# A d d e n d u m

Iowa Department of Transportation  
Office of Contracts

<b>B.O.</b>	<b>Proposal ID</b>	<b>Proposal Work Type</b>	<b>County</b>	<b>Project Number</b>	<b>Addendum</b>
105	66-C066-067	PCC OVERLAY- UNBONDED	MITCHELL	FM-C066(067)--55-66	21MAR105A02

TYPICAL BRIDGE APPROACH DETAIL  
STA 151+57.00 - 157+72.00

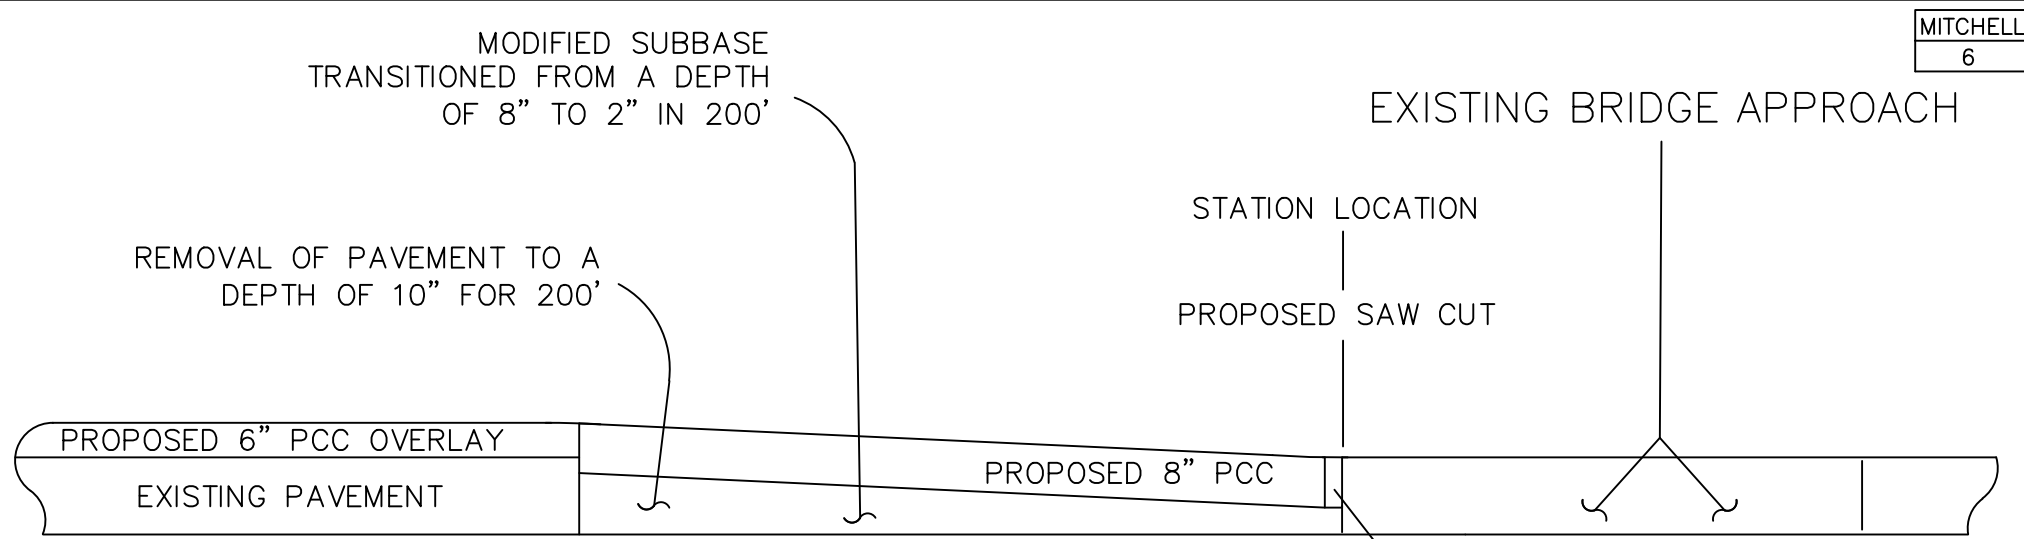
Sheet B.02,  
Replace entire sheet with the attached sheet. (Joint details amended from previous detail)

LONGITUDINAL  
L-1 JOINT  $\geq 6" < 8"$   
KT-1 JOINT  $\geq 6" < 8"$  (if done single lane)  
L-2 JOINT  $\geq 8"$   
KT-2 JOINT  $\geq 8"$  (if done single lane)

TRANSVERSE  
C JOINT  $< 8"$   
CD JOINT  $\geq 8"$

TYPICAL BRIDGE APPROACH DETAIL  
STA 320+31.85, 325+08.00, 350+40.17, 352+53.00

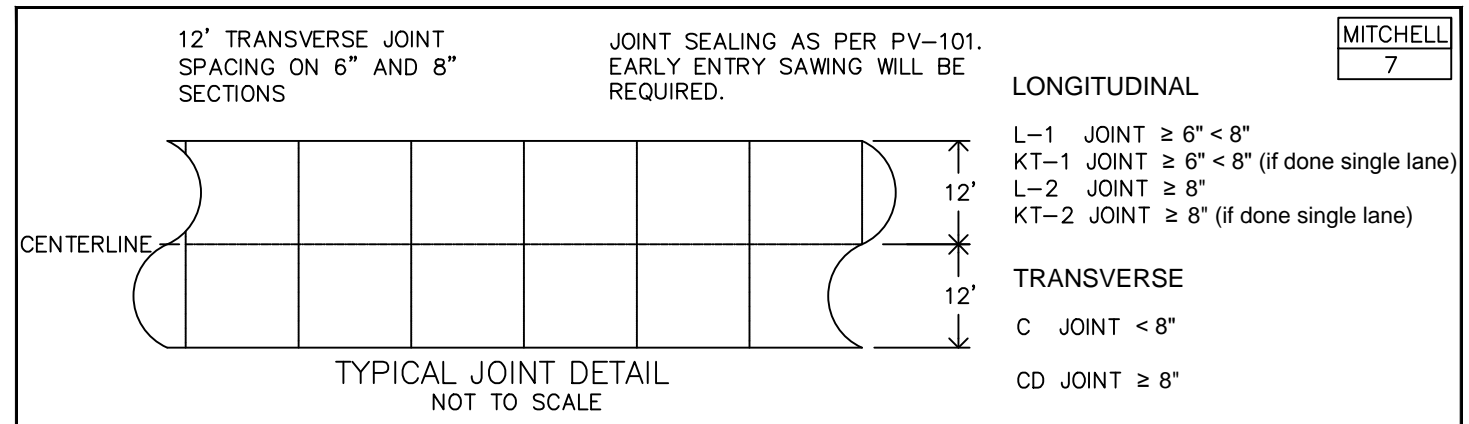
Sheet B.03,  
Replace entire sheet with the attached sheet. (Joint details amended from previous detail)

- L-1 JOINT  $\geq 6" < 8"$
- KT-1 JOINT  $\geq 6" < 8"$  (if done single lane)
- L-2 JOINT  $\geq 8"$
- KT-2 JOINT  $\geq 8"$  (if done single lane)

- C JOINT  $< 8"$
- CD JOINT  $\geq 8"$
